TELOPEA STAGE 1A

DPE RFI RESPONSE

13/12/2023

DPE RFI 6 NOVEMBER COMMENT

2.1a.) Building E Basement (Neighbourhood Park)

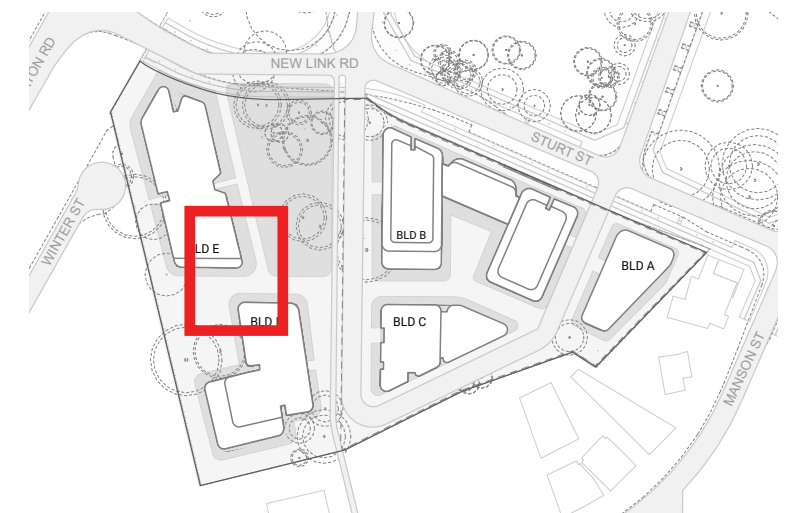
The Subdivision Plans show the south-eastern corner of the Neighbourhood Park will not be dedicated to Council, while the Landscape Plans incorporate this space as part of the public park. **The Department does not support shared ownership of the public park** noting potential access, maintenance, and liability conflicts. Accordingly, **reduce the Stage 1A basement footprint so that it does not extend east beyond the building line of Building E.**

Since the preparation of the previous RTS Package, FPA have discussed with Council that they are intending to keep neighbourhood park in private ownership.

This will allow FPA to manage the park via a strata arrangement and avoids any management issues associated with any basement footprint below.

BUILDING_B BEFORE

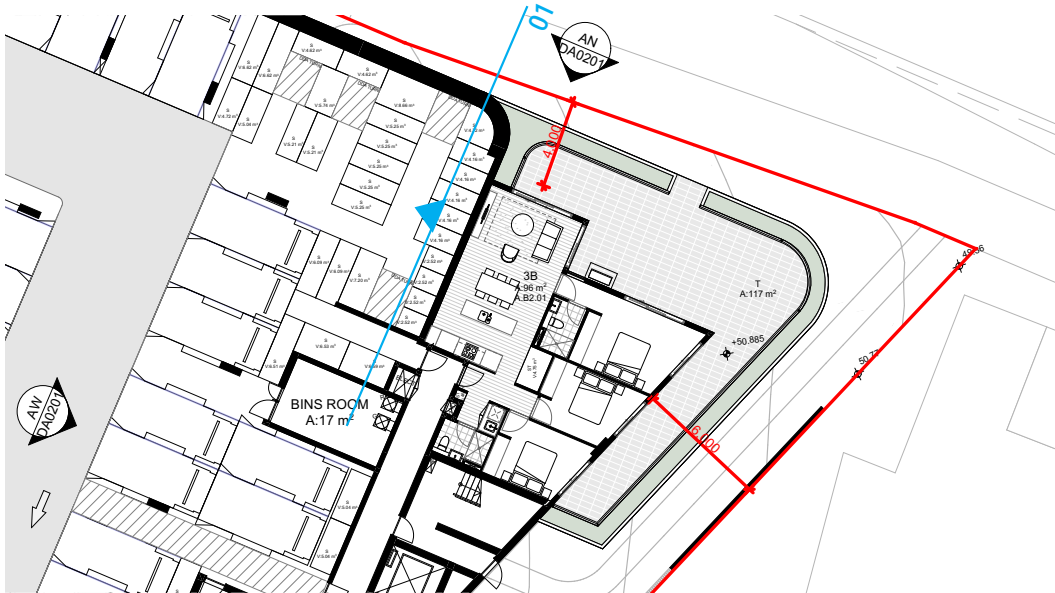
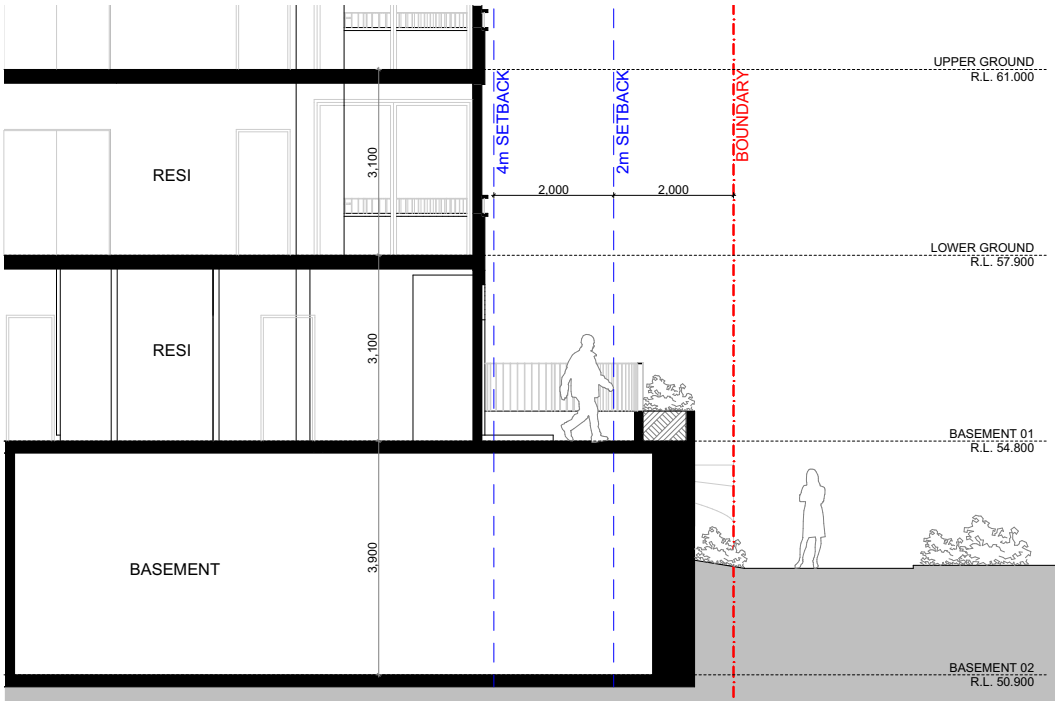
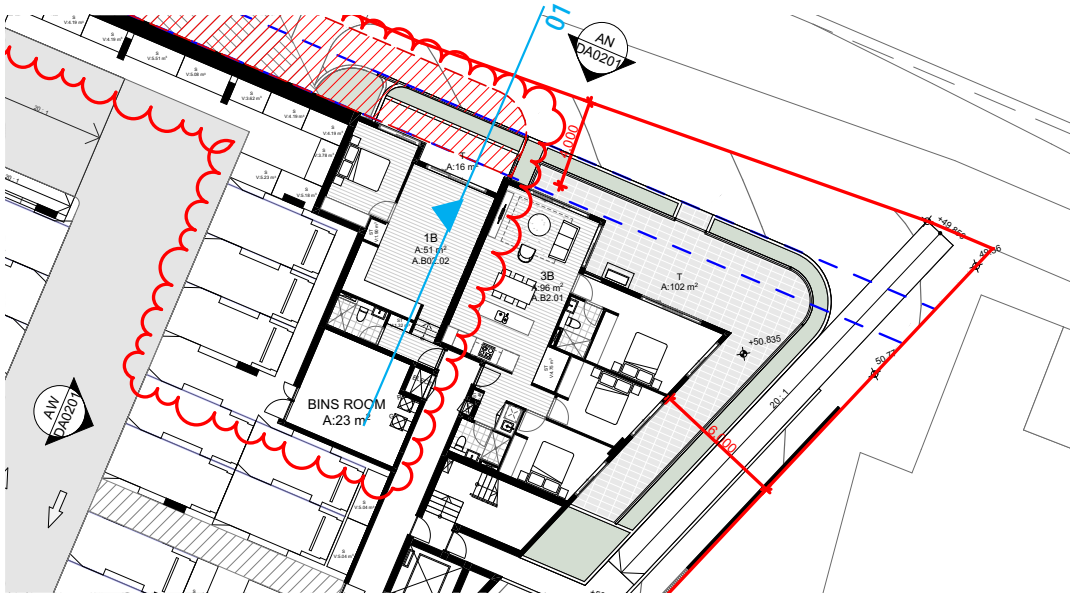
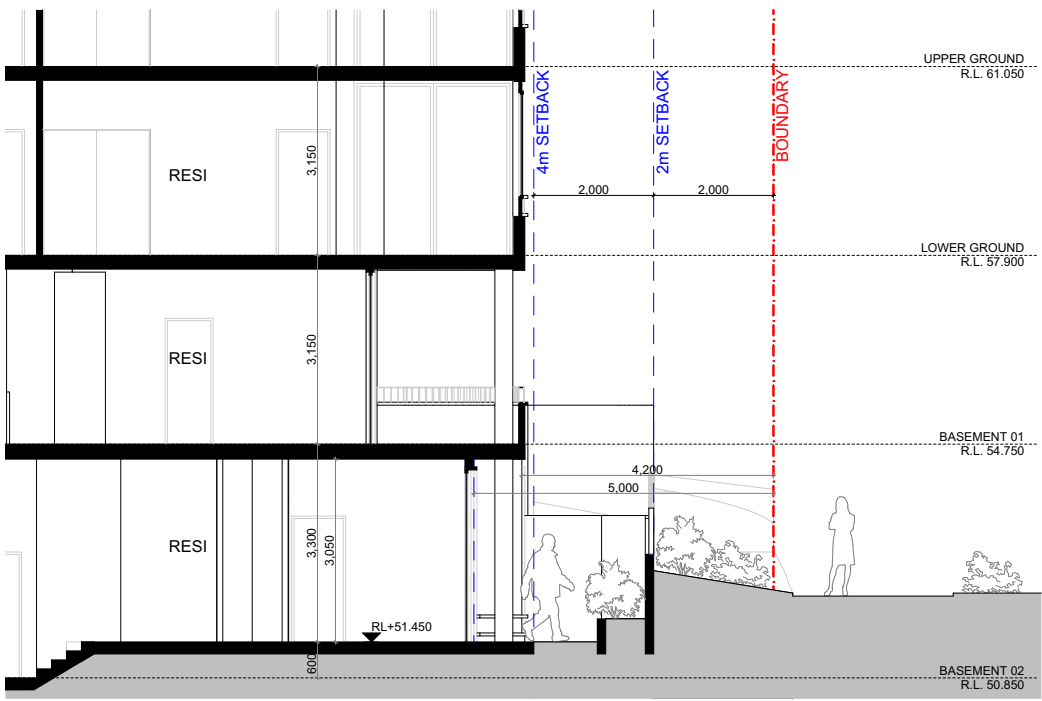
2.1.b.
The Department raises concerns about the proposed Building A and B basements projecting above the finished ground level along Sturt Street as it would result in large blank walls to the street. Amend the buildings’ design to ensure it achieves an appropriately designed interface to the street.

To address DPE's comments, refined plans have been prepared by Plus Architecture (refer to Appendix A).

Amendments to Buildings A and B aim to reduce blank walls to the Sturt Street frontage and reflect Council's request for a minimum setback of 4 metres to be free of basement structure in order to establish thriving trees and landscaping. Specifically, to the Architectural Plans include:

Building A corner balconies

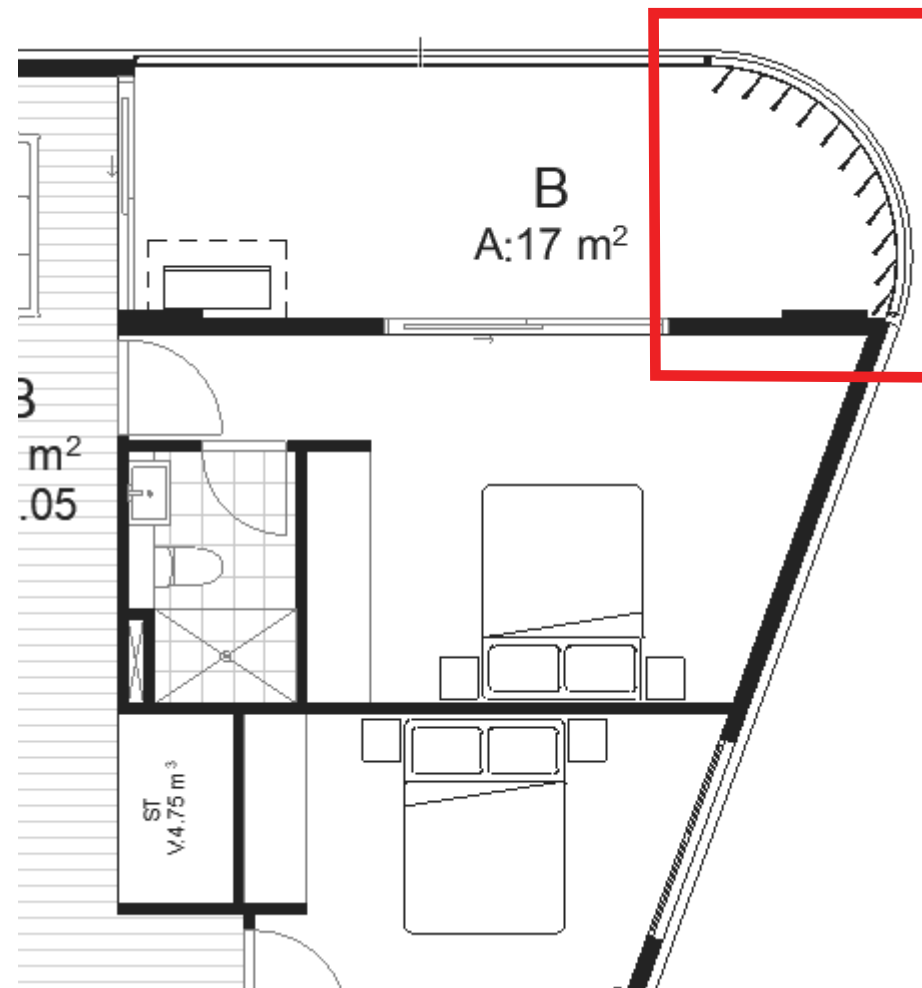
Confirm how Stage 1A addresses the recommendations of the Wind Impact assessment, specifically that the **upper-level dual aspect balconies at the corners of Buildings A to E are to be designed as nested/single aspect balconies** including full height balustrade, wing walls, wind screens or other practical shielding.

Refined plans for Stage 1A have been prepared by Plus Architecture (Appendix A) which include the introduction of full height screening to nest in affected balconies.

Building E corner balconies

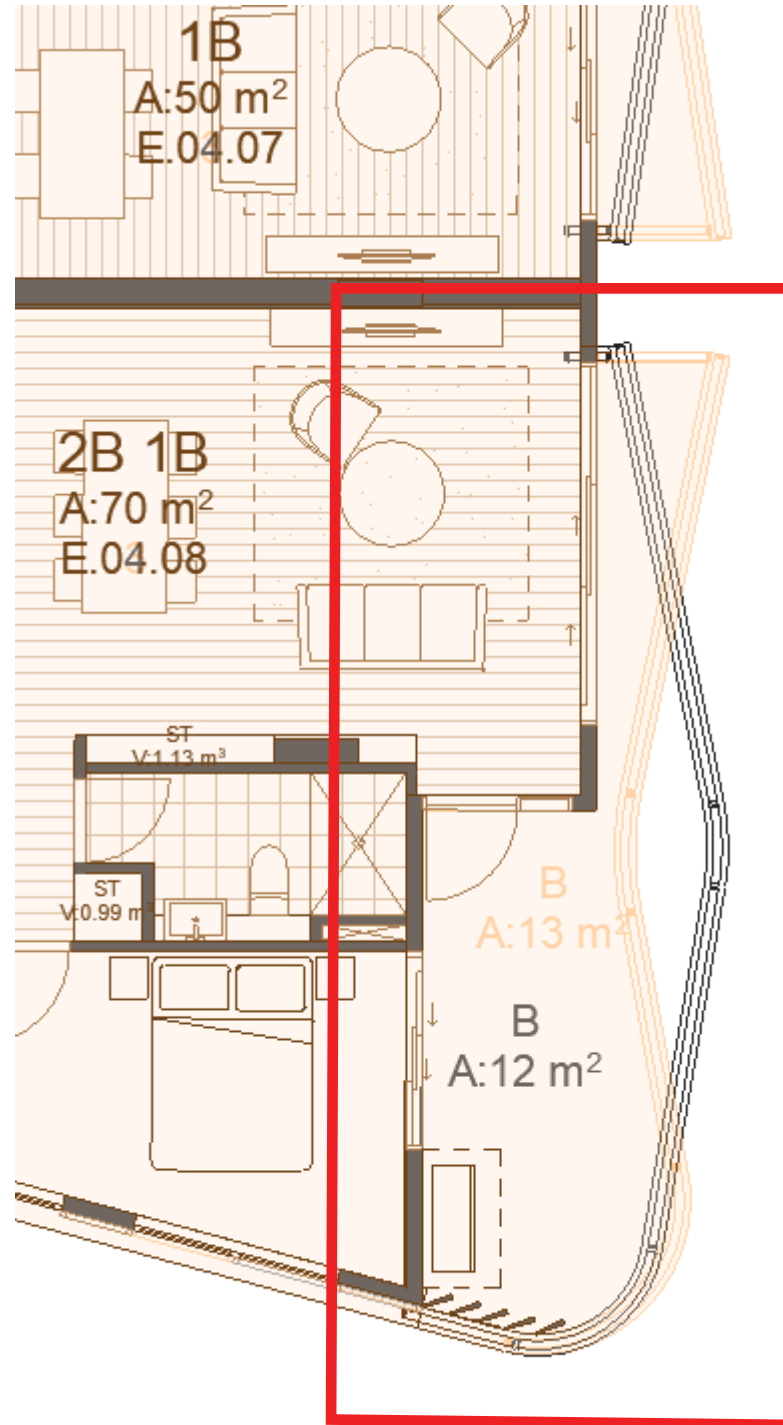
Confirm how Stage 1A addresses the recommendations of the Wind Impact assessment, specifically that the **upper-level dual aspect balconies at the corners of Buildings A to E are to be designed as nested/single aspect balconies** including full height balustrade, wing walls, wind screens or other practical shielding.

Refined plans for Stage 1A have been prepared by Plus Architecture (Appendix A) which include the introduction of full height screening to nest in affected balconies.

BUILDING_C TERRACE BEFORE

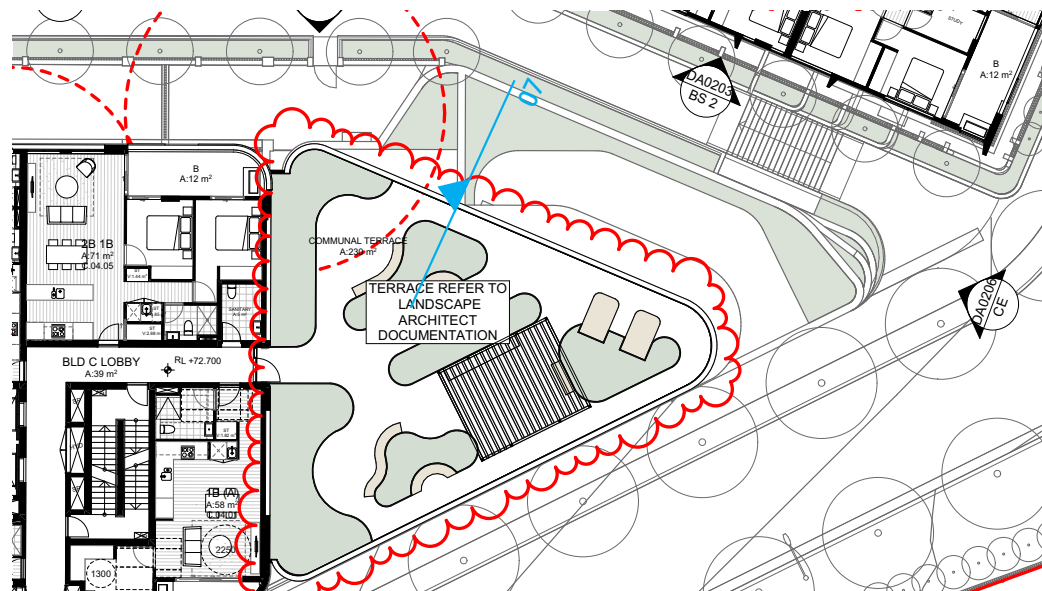
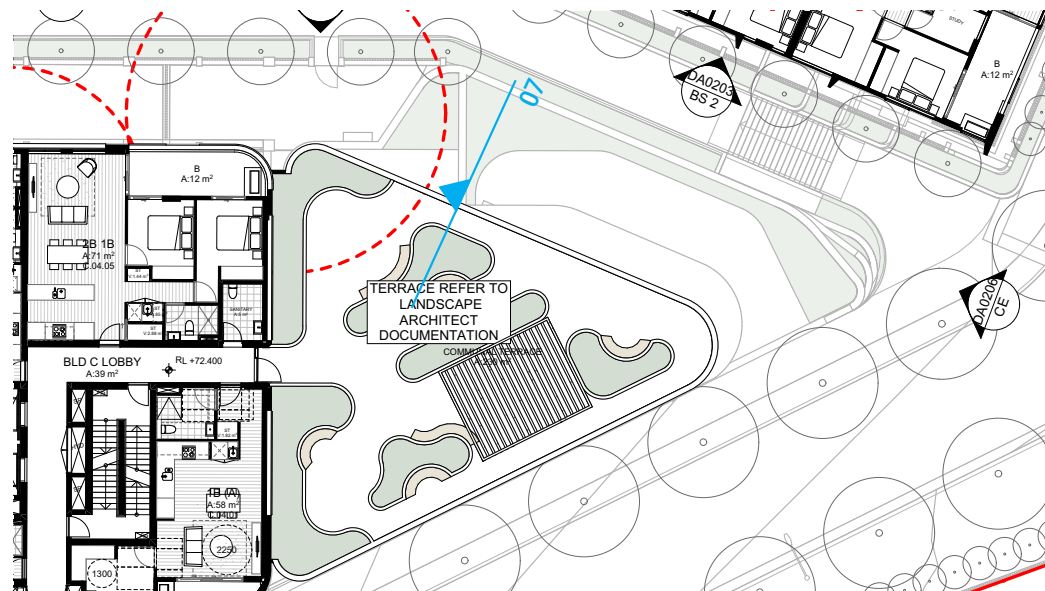
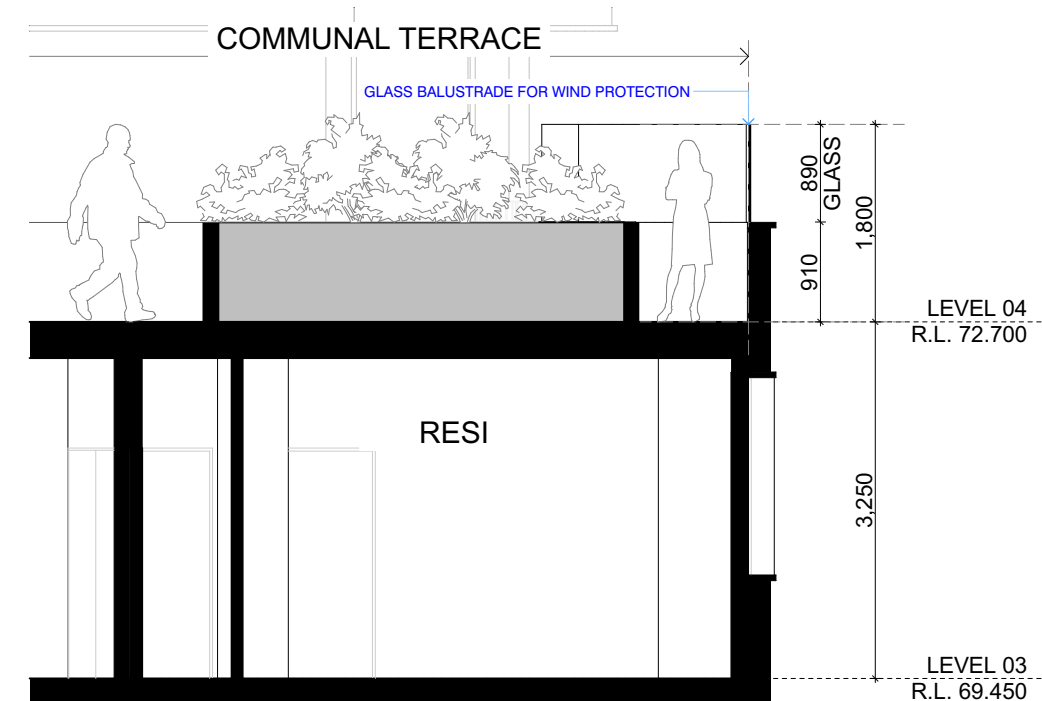
2.1.e.
Confirm that a minimum 1.8 m tall balustrade/landscaping will be provided around the perimeter of communal open space on Level 4 of Building C and Level 5 of Building B.

Refined plans for Stage 1A have been prepared by Plus Architecture (Appendix A) which incorporate a minimum 1.8 m tall balustrade on the Building B and C rooftop communal open space.

Given the open space will remain open to the sky and not provide enclosed weather protection, the introduction of 1.8m balustrades will not constitute additional gross floor area.

2.1.f.) Floor to floor height

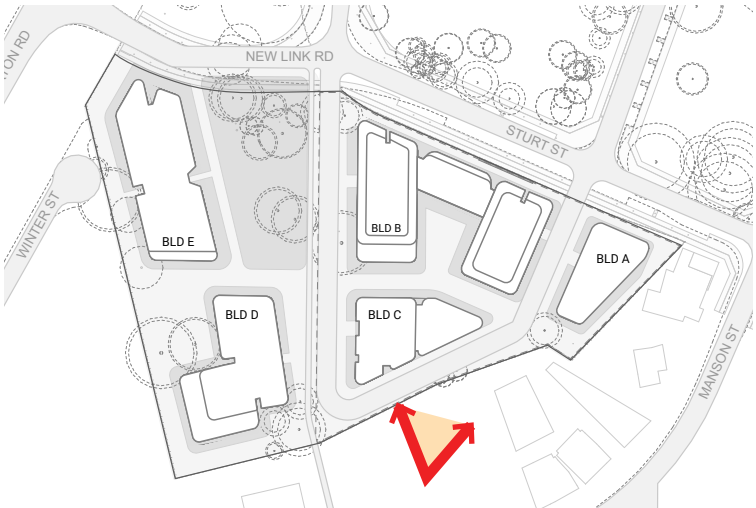
Confirm why a **3.15 m floor to floor height** is not required for Stage 1A buildings, noting this standard has been adopted for the building envelopes within the Concept Proposal, citing the need to comply with the National Construction Code 2022.

Refinements to the Stage 1A Architectural Plans have adopted 3.15m floor to floor heights to meet NCC requirements. The Clause 4.6 Variation for height in Stage 1A prepared by Urbis (refer to Appendix G) has been updated to reflect these refinements.

Additional increase in heights are from added 1.8m high screening to communal open areas, ad additional liftoverrun on building A.

3.1.a.) Neighbourhood Park

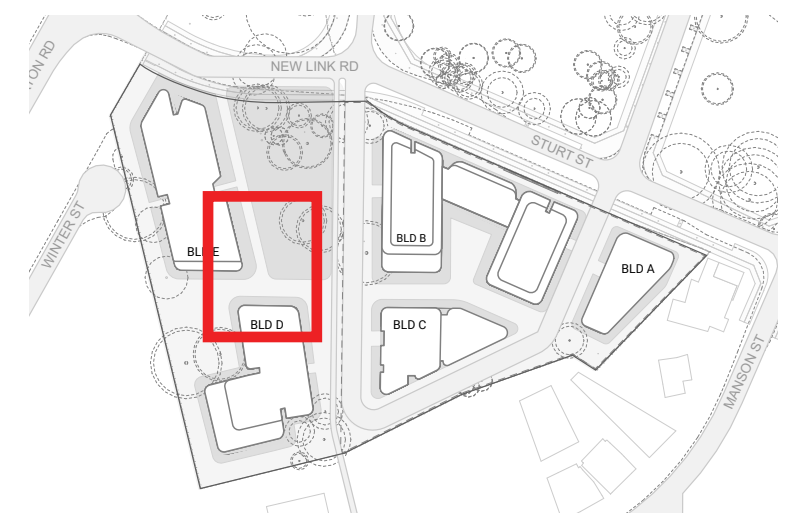
The Neighbourhood Park should be free of all basement structures. A review of the Subdivision Plan, Landscape Plan and Basement Plan indicates a basement encroachment of the western side of the Neighbourhood Park (refer red hatched line at Figure below).

Although the encroachment is excluded in the subdivision plan, this will complicate future liability and maintenance responsibility for Council.

3.1.e.) Building A Communal Area

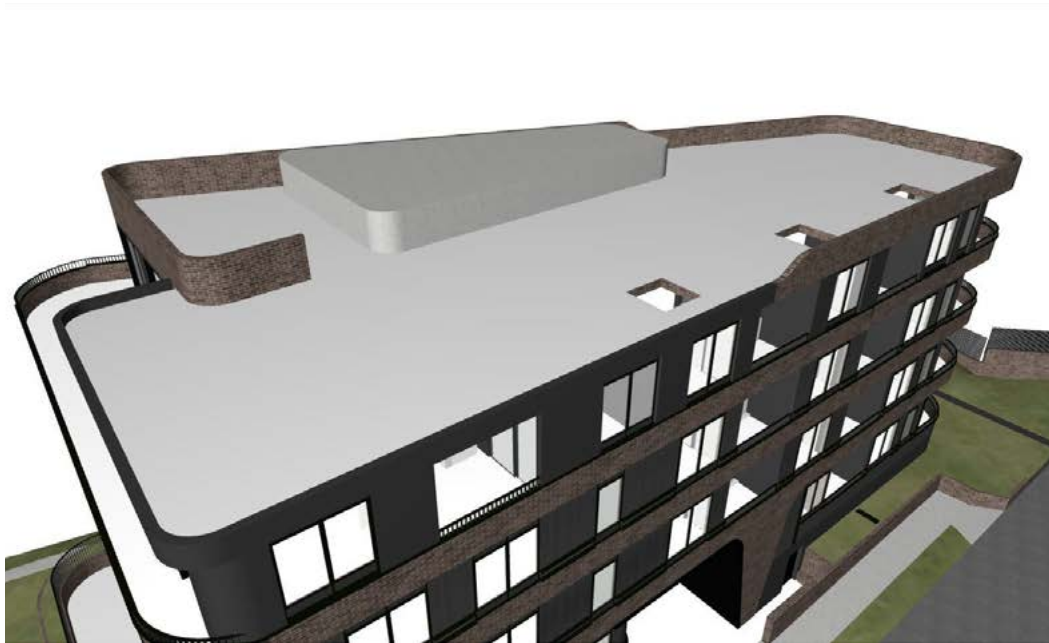
e) Building A Communal Open Space –the open space for residents does not meet minimum solar access requirements, has poor accessibility and inadequate size and dimensions.
Furthermore new courtyards sit 1.5 metres above the existing ground level on the property boundary which creates privacy conflicts.
